### Addendum #2

Project: 20240606 - BL000A Site - Replace Section of 12470V Circuit 104 and 106

Date: December 4, 2025

€ E183

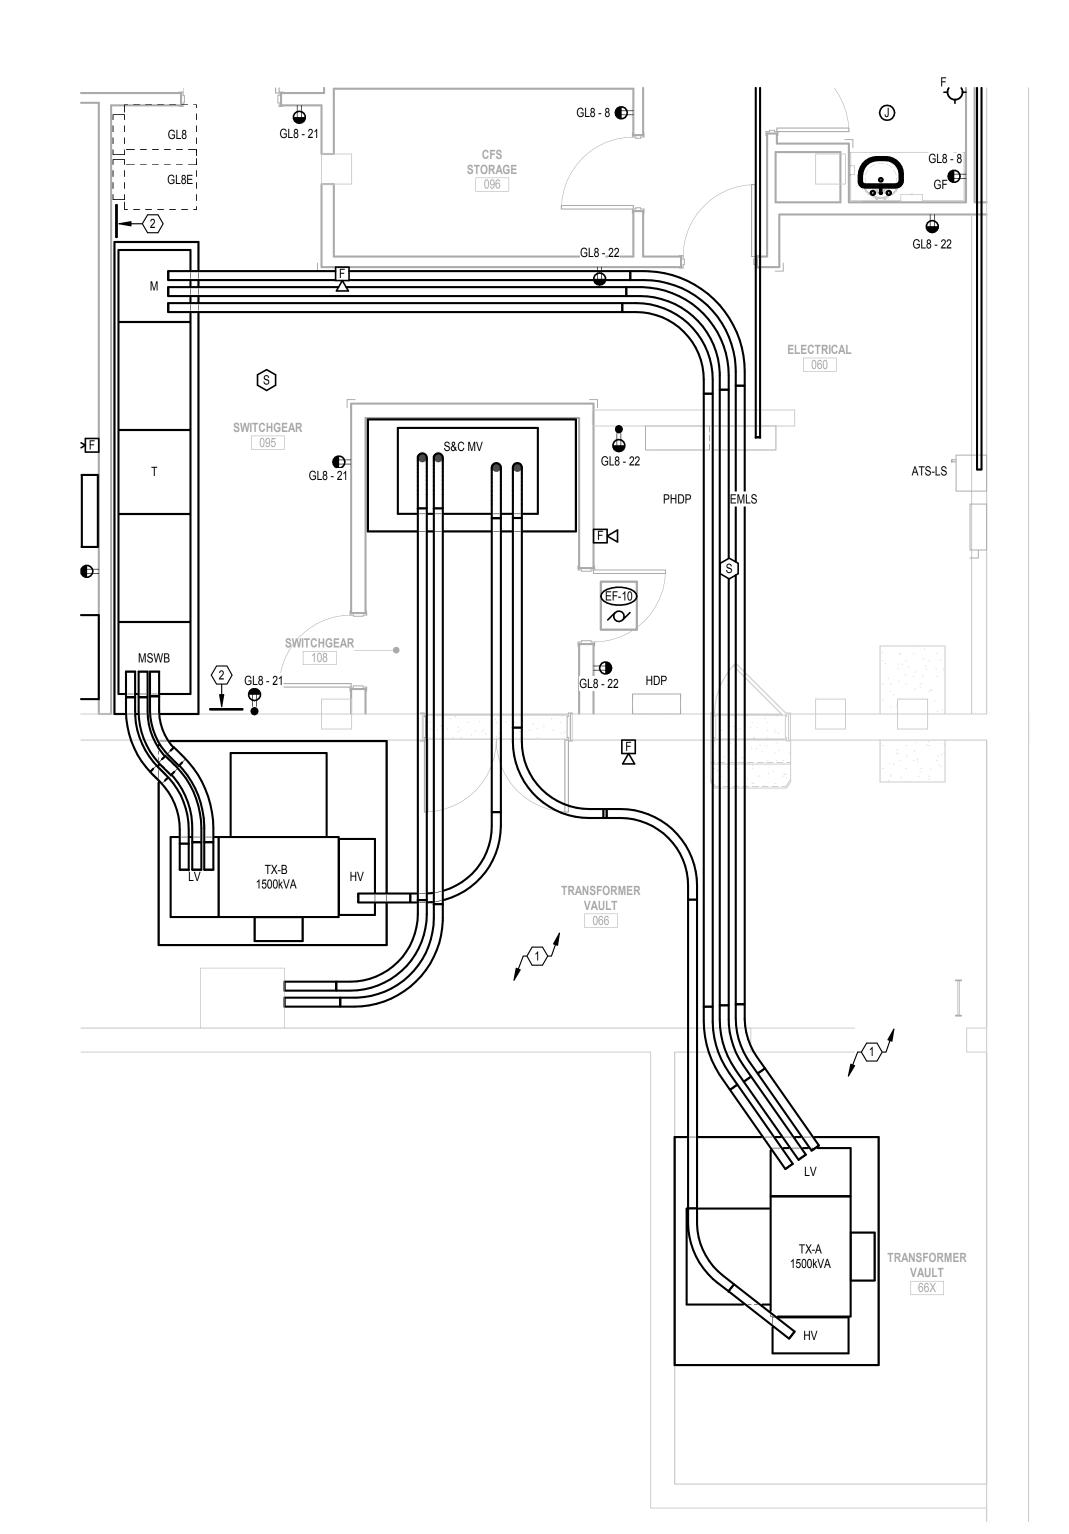
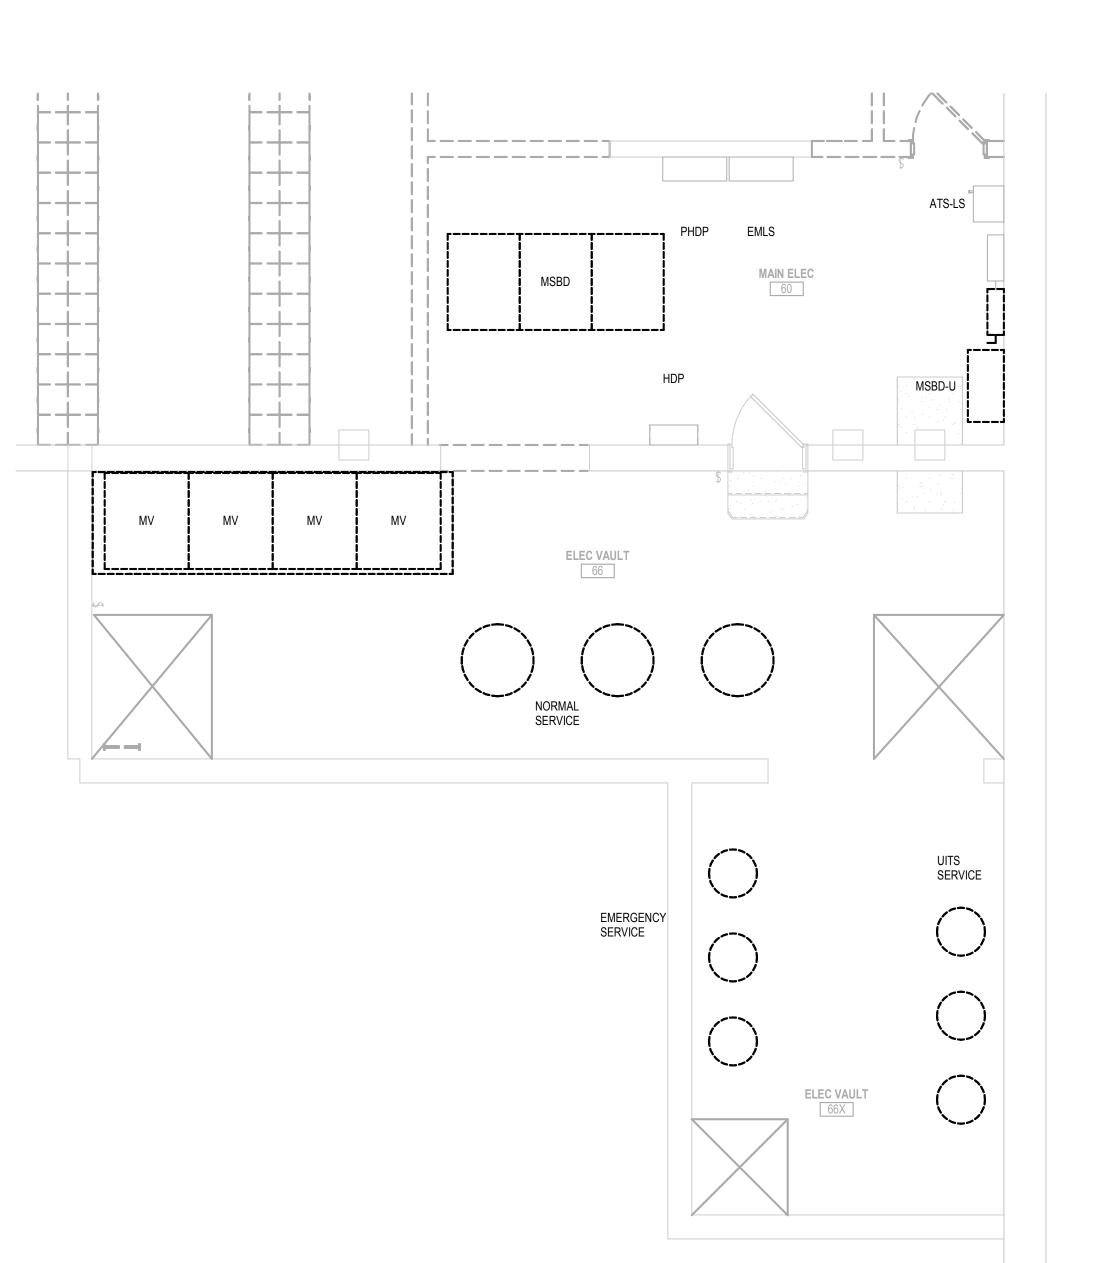
Attached School of Public Health electrical vault layout drawing is for reference only.
